TO: Mercedes-Benz Dealer Principals, General Managers, Sales Managers, Service Managers, Parts Managers	FROM: Thomas Brunner, Department Manager, Vehicle Compliance and Analysis, Engineering Services
RE: Recall Campaign 201703030003 LAUNCH Notification MY 2017 Model 213 (E-Class) Inspect/Replace Occupant Classification System (OCS)	DATE: March 3, 2017

Campaign No. 2017030003 March 2017

SUBJECT: **Models 213, Model Year 2017**
Check Routing of Corrugated OCS Pressure Tube

Figure 1

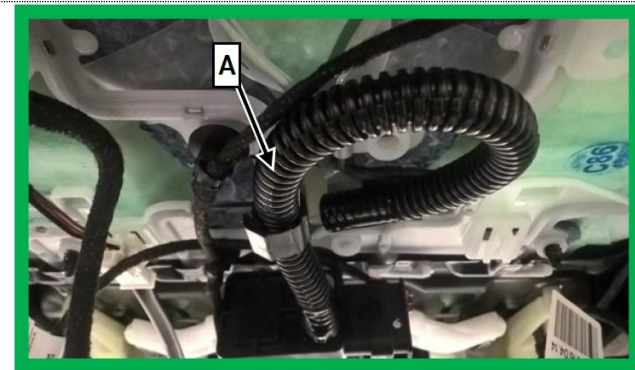
1. Move the passenger seat forward and upward to provide visibility under the seat.
2. Check routing of corrugated OCS pressure tube (A, Figure 1):
 - The correct routing is shown in (A): Large continuous loop (**OK**): Procedure is complete.
 - Incorrect routing is shown in (B): Kink or twisted loop (**NOT OK**): Proceed to step 3.

3. Create a PTSS case in the event corrugated OCS pressure tube is kinked:
 - Submit pictures of kinked corrugated OCS pressure tube along with VIN.
 - i** **Note:**
 - Pictures submitted must be of good quality and high resolution.
 - No SDS print out is required.
 - Wait until guidance is provided by Engineering Services.
